SERVICE BULLETIN

NUMBER: 12-145-13

SUBJECT: Condensation in Rear Combination Lamps, Retaining Nut Change

DATE: 02/15/13

Revised Nut, 15mm diameter flange surface

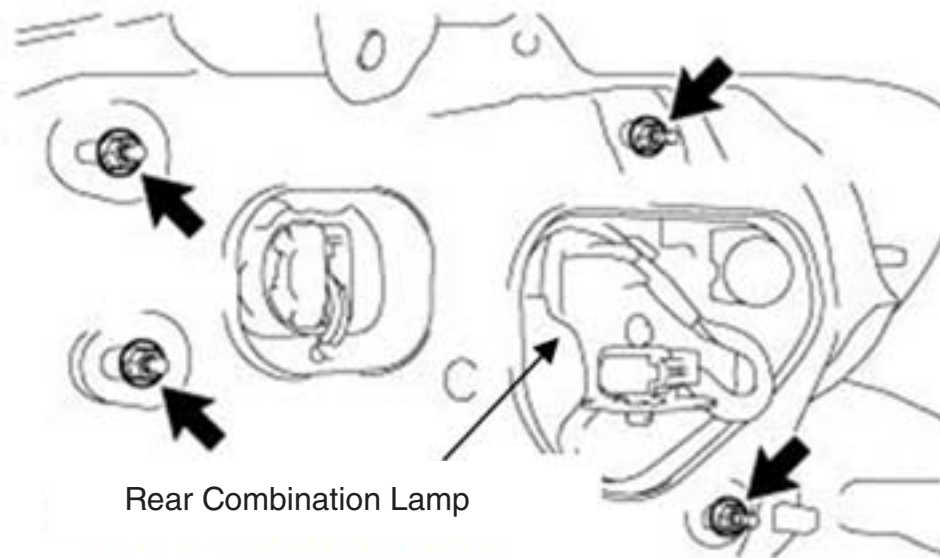
Due to a smaller diameter flange surface, the original retaining nuts may distort the rear body panel mounting and sealing surfaces for the combination lamps enough to allow moisture seepage past the seals into the combination lamps and possibly the trunk area.

The revised retaining nuts with a larger diameter flange surface were incorporated into production starting with VIN D*605847.

Original Nut, 12mm diameter flange surface

L/H Sequence

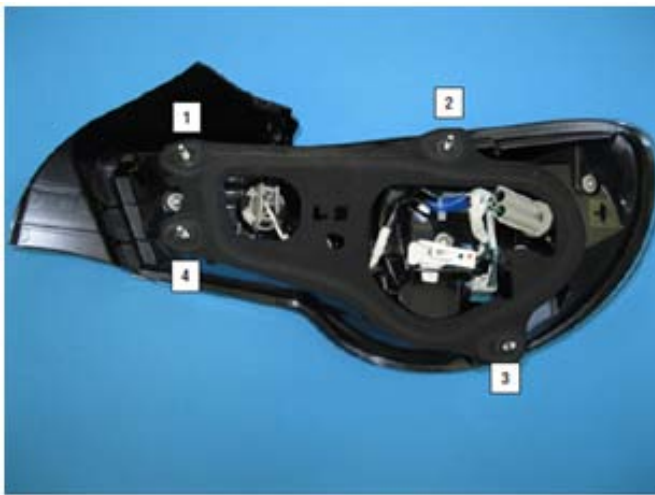
- Before reinstalling any combination lamp assembly (original or replacement), always install a new sealing gasket as they are one-time use items.
- The proper torque sequence must be followed as shown in the following illustrations or damage to the combination lamp assembly may result. The torque specification (unchanged) for the retaining nuts is 4.5 Nm (39 inch-pounds).
